SITE NAME:
 FOUNTAIN VALLEY
 SITE ID:
 COUG000-RELO
 COLOG000
 13250 RAY NIXON RD.
 FOUNTAIN, CO 80817
 EL PASO

NEW NORTHEAST
 ELEVATION

A3.1

3 NEW NORTHEAST ELEVATION (NEW RELO SITE AT MONOPOLE)

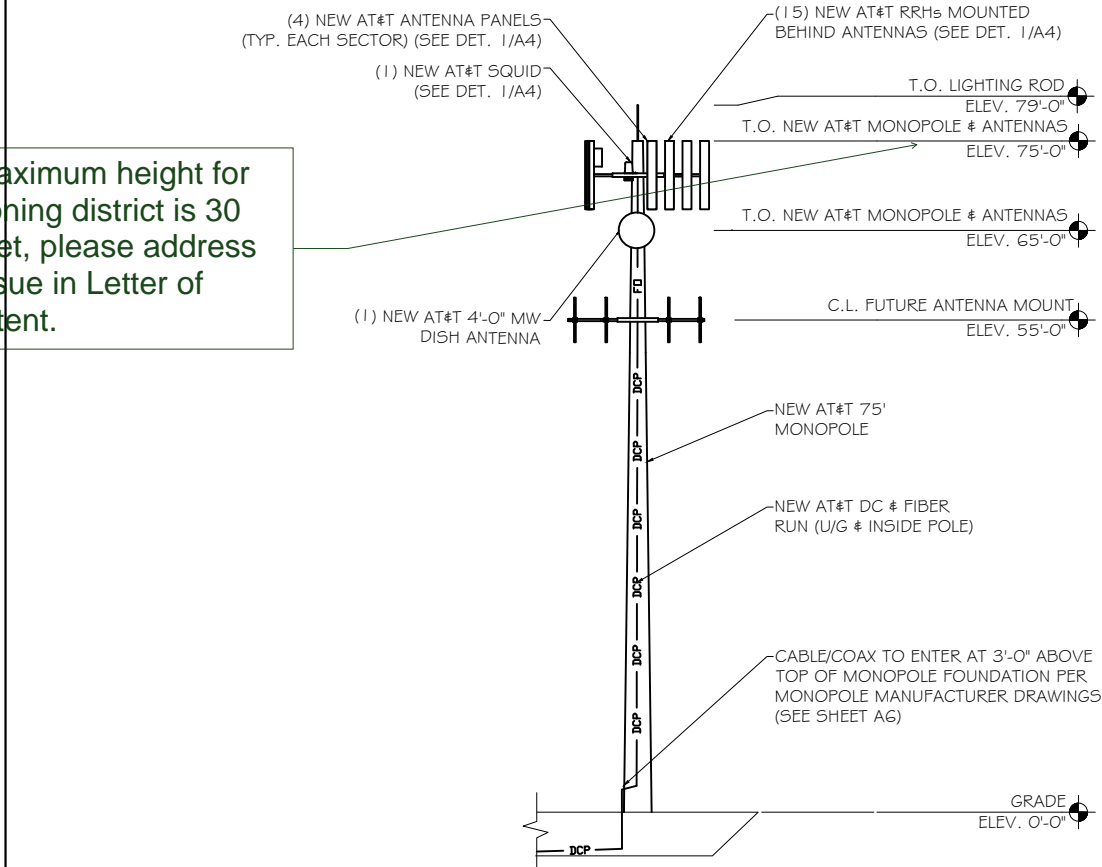
Maximum height for zoning district is 30 feet, please address issue in Letter of Intent.
